RE: **Beltran Townhomes**
2125 St. Cyr SE
Grading Plan Stamp Date: 2/25/20
Hydrology File: K15D105

Based on the submittal received on 2/26/20, this project cannot be approved until the following corrections are made:

GRADING AND DRAINAGE PLAN

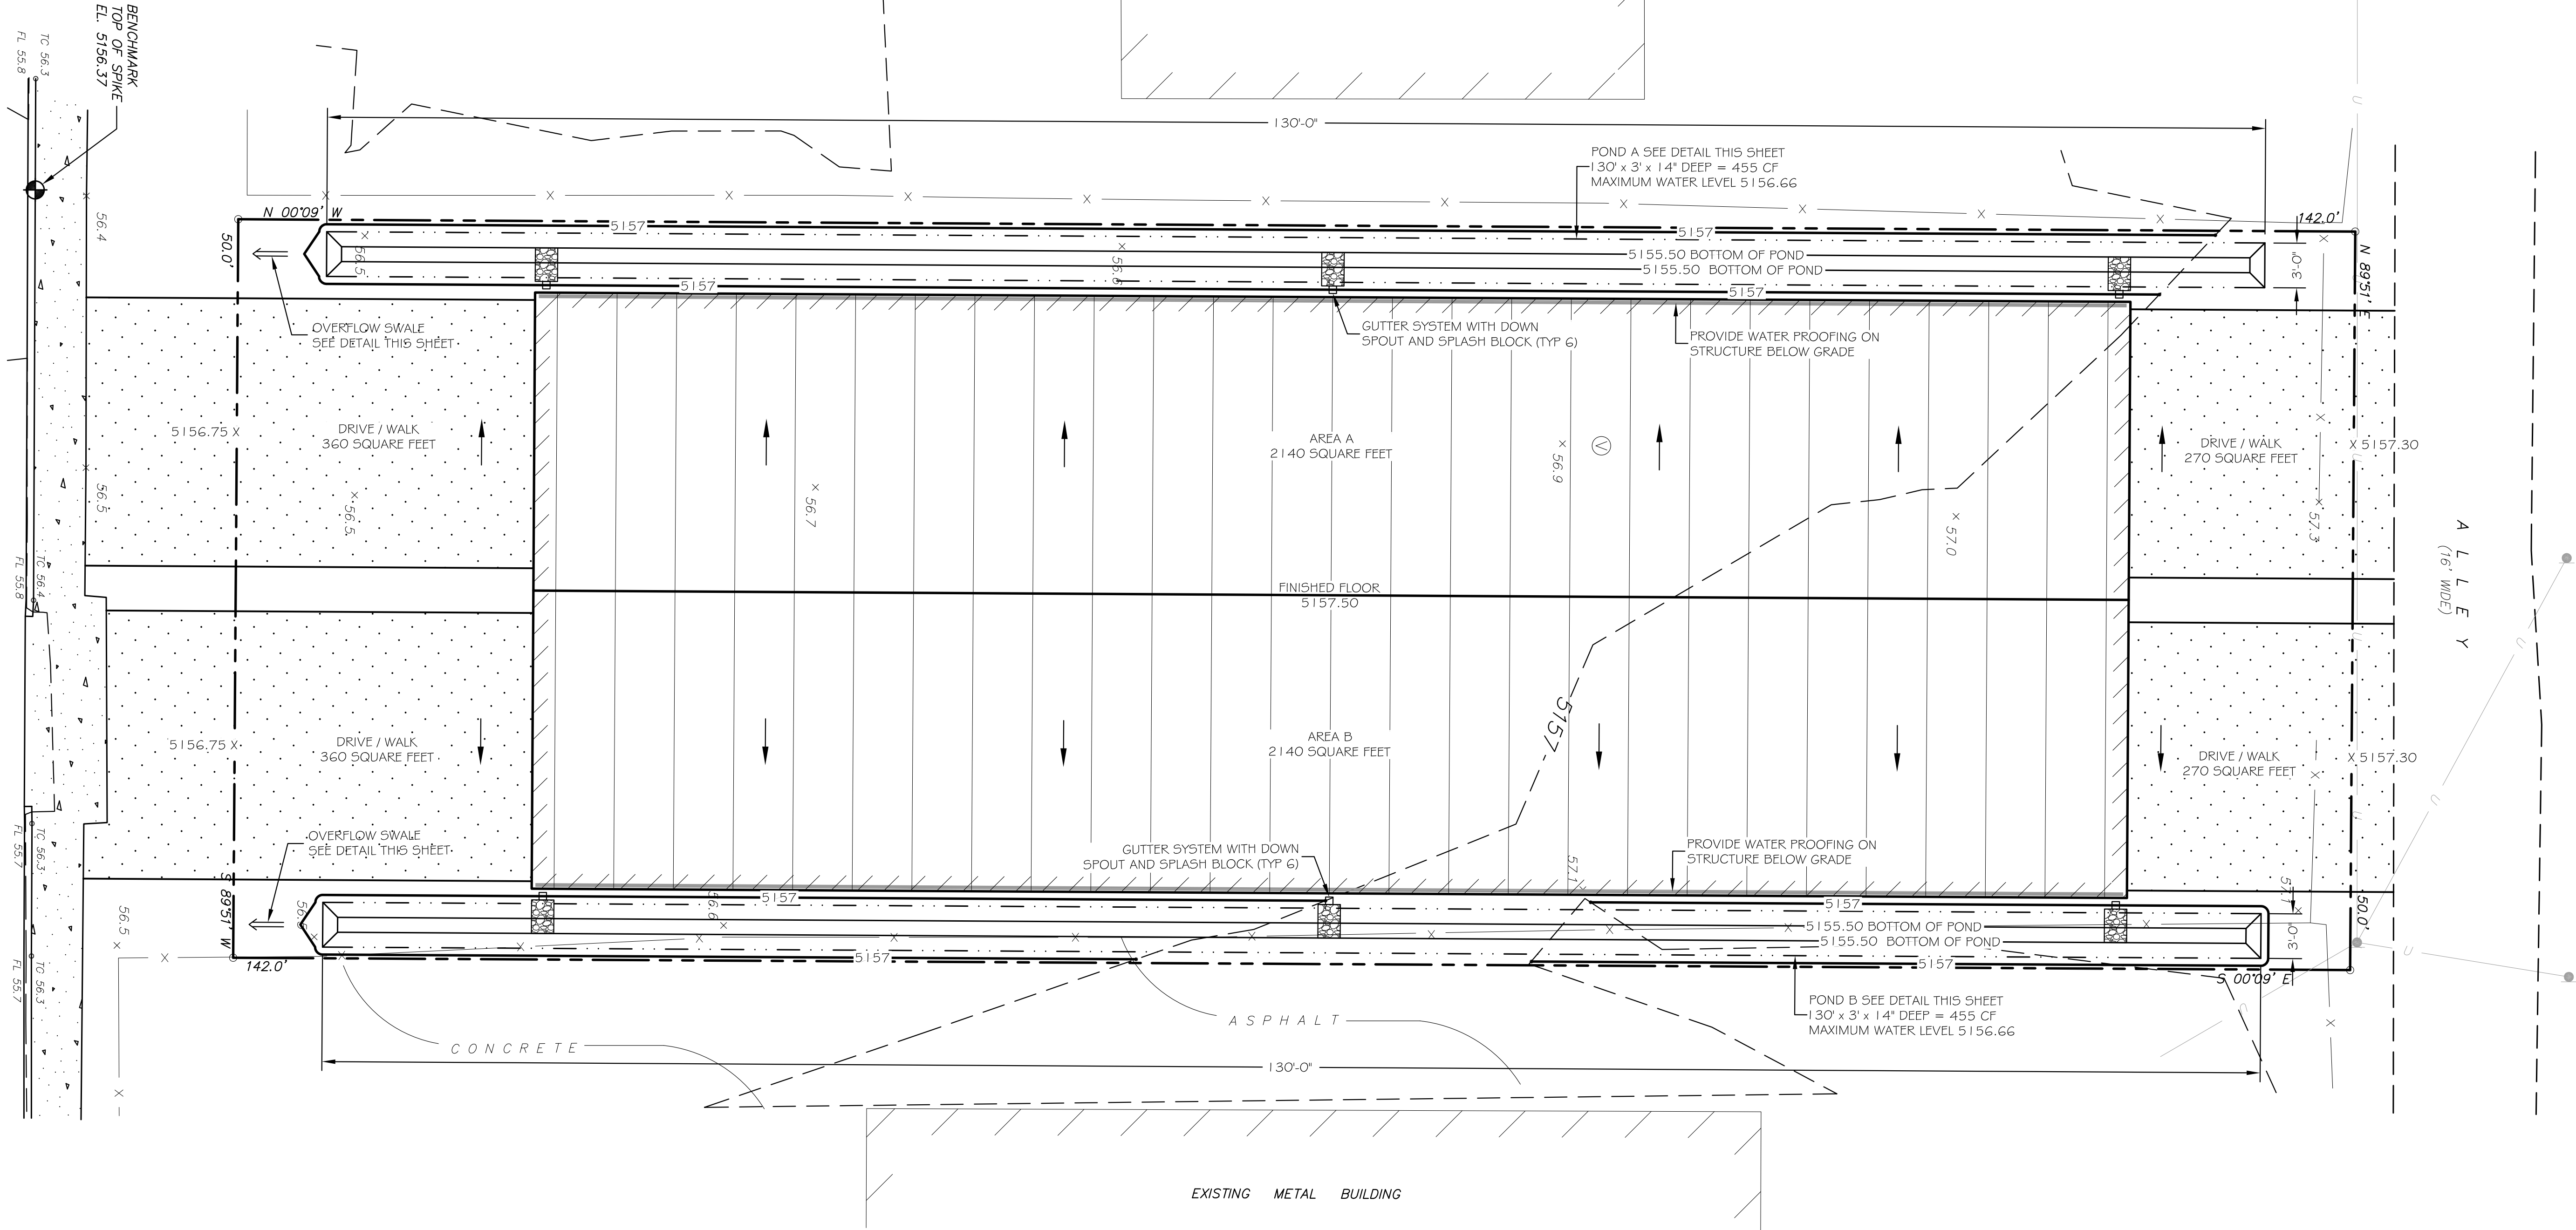
1. Include project datum; all existing survey, proposed grades, and benchmarks must be provided in NAVD 88.
2. Please provide an engineer's stamp with a signature and date. This got stripped in the pdf.

3. Please provide the legal description of the property on the Grading Plan.
4. Provide Hydrologic calculations per the DPM Ch 22.A. If using the Rational Method, C and i values presented in the DPM Ch. 22.A.6.3, Table A-10, and Table A-11 must be used.

5. Provide a scaled drainage basins delineation figure, showing the areas of impervious and pervious cover and land treatments.
6. The site must demonstrate adequate downstream capacity per § 14-5-2-12(G) of the Albuquerque Code of Ordinances or retain increased runoff onsite (peak flow and volume). The proposed ponds are substantially undersized as they are based on faulty Hydrologic analysis and site assumptions.

7. Please include a label on each Pond with the stormwater quality volume and elevation, the 100-year volume and elevation, the peak 100 year inflow and outflow, the spillway crest elevation, the spillway flow depth, and the top of pond elevation.

8. Provide sections through both external boundaries showing proposed retaining walls, garden walls, property/ROW lines, existing and proposed grades on both sides of the property line. In accordance with DPM Ch.22, section 5 part B, grading and wall construction near the property line may not endanger adjacent property or constrain its use.
